TABLE OF CONTENTS

B. Project 2021-04 Modifications to PRC-002-2 Disturbance Monitoring.....	16
C. Project 2020-02 Modifications to PRC-024 (Generator Ride-through)	17
D. Project 2023-02 Analysis and Mitigation of BES Inverter-Based Resource Performance Issues.....	18
VI. JUSTIFICATION FOR APPROVAL: PROPOSED RELIABILITY STANDARD PRC-029-1	19

- A-1 Proposed Reliability Standard PRC-024-4 – Clean
- A-2 Proposed Reliability Standard PRC-024-4 - Redline
- A-3 Proposed Reliability Standard PRC-029-1

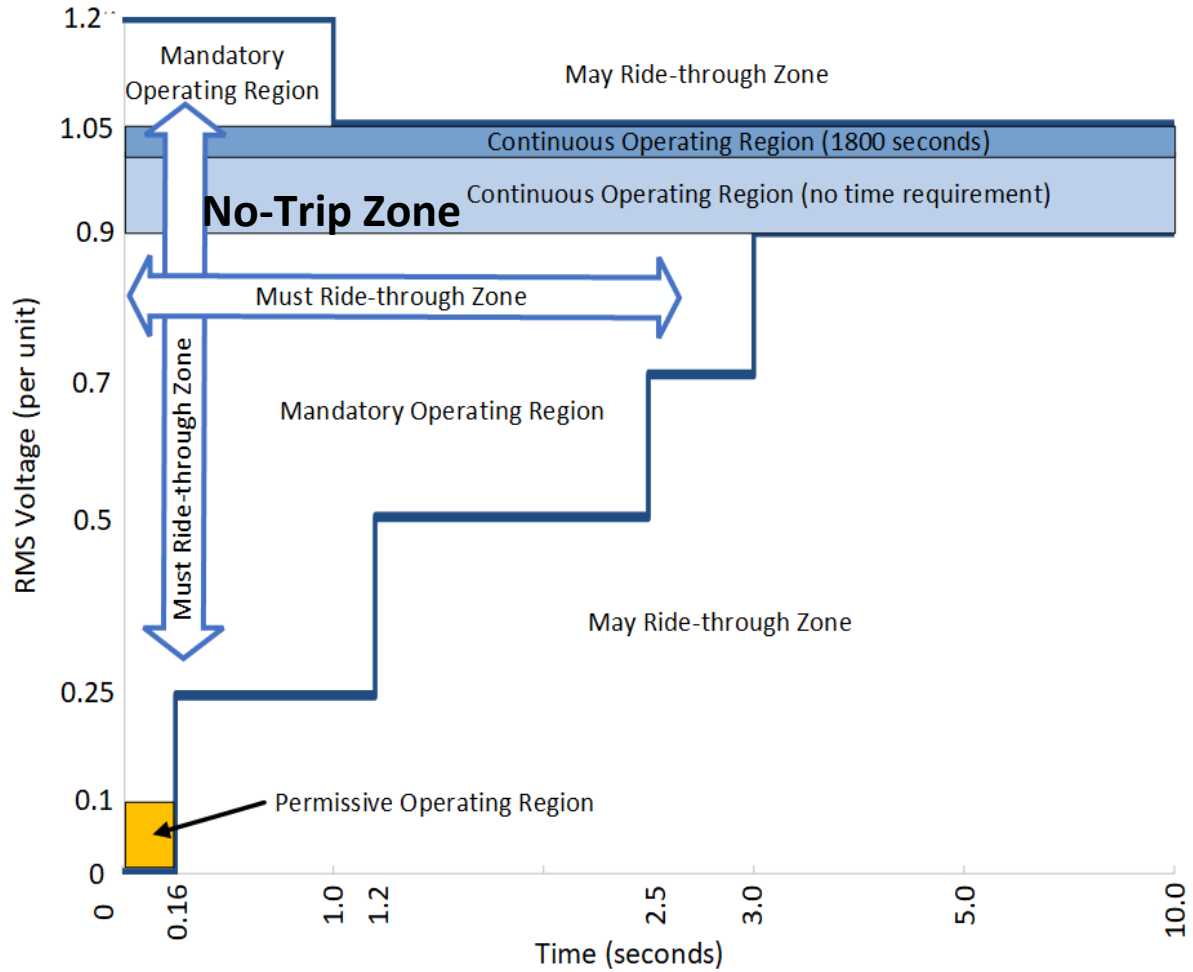
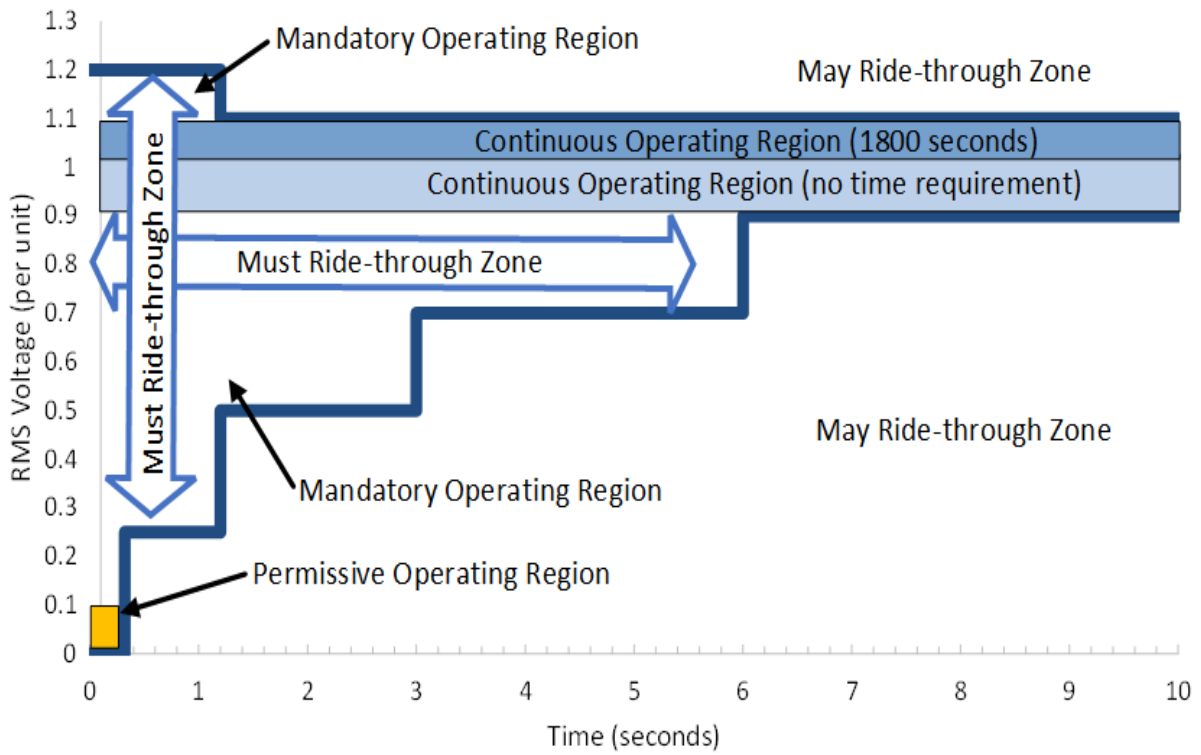
The SRC recommends that the SDT to review and align the data in **Attachment 1** to ensure that the data in Tables 1 and 2 aligns with what is shown in Figures 1 and 2. Currently, the graphs in Figures 1 and 2 do not match what is indicated in the Tables. For example, rows 1-3 in Tables 1 and 2 are identical, yet Figure 2 does not match Figure 1 by indicating a Voltage Ride-Through Requirement of 1.0.

There is a discrepancy between the definition of the Term “Mandatory Operating Region” which states “≤ 1.2 per unit” and Table 1/Figure 1 or Table 2/Figure 2 which state “≥1.200” per unit “N/A”. Please clarify if Table 1/Figure 1 and Table 2/Figure 2 should state “>1200” or if the definition of the Term “Mandatory Operating Region” should state “<1.2 per unit”.

Please clarify Figure 1 and Figure 2 to clearly show the “Continuous Operating Region”, “Mandatory Operating Region”, and “Permissive Operating Region”, along with requirements beyond 10 seconds.

R1/R2: Recommend that Attachment 1 have a chart to include the Continuous Operation Region, Mandatory Operation Region, and Permissive Operation Region or have those regions specified on existing Voltage Ride-through Requirements Figure 1 and Figure 2.

Figure 3: PRC-029 Frequency Ride-Through Requirements

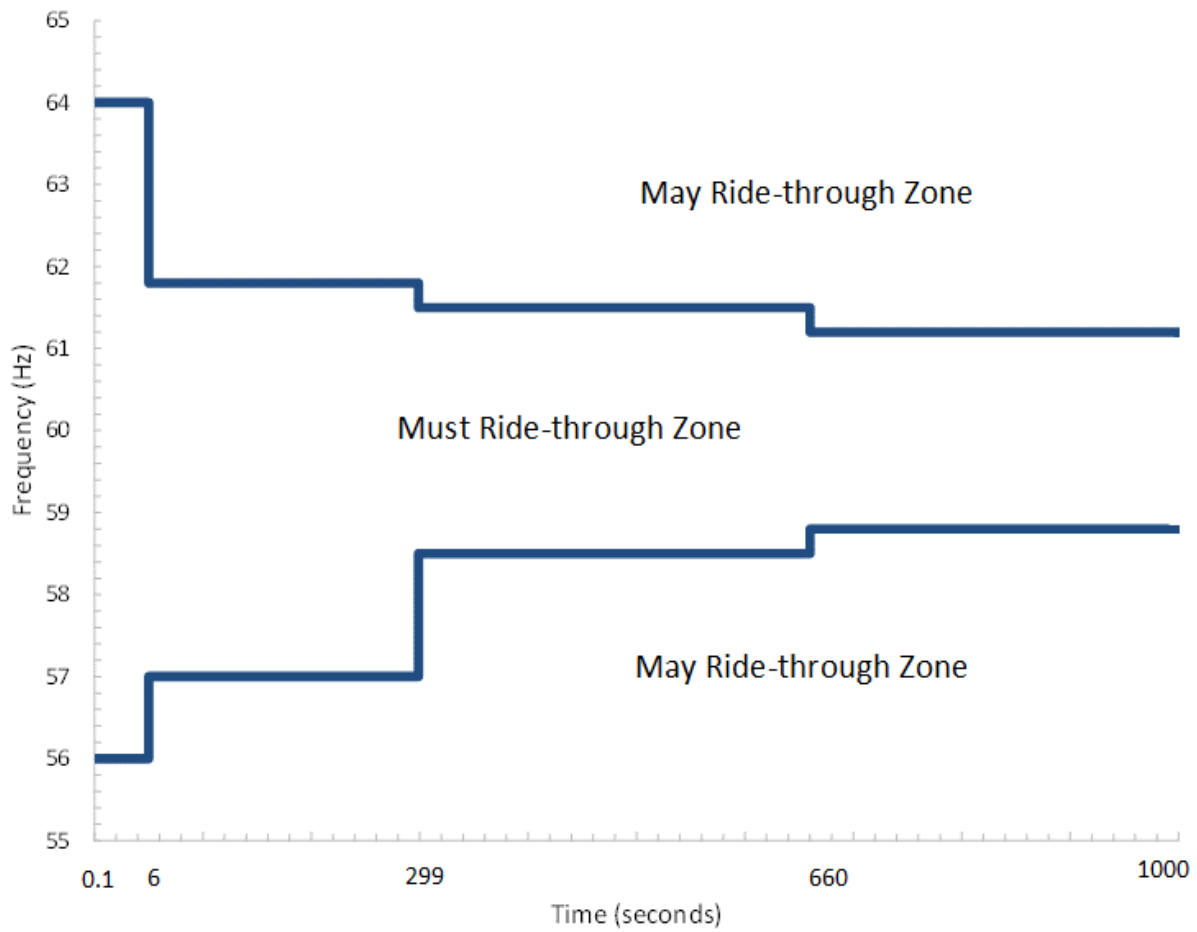
Duke Energy also recommends, if not already considered, to verify with OEMs that the inverters can satisfy Att 2. Figure 3 does not align with IEEE 2800 Figure 14; again, making compliance with both requirements more complicated.
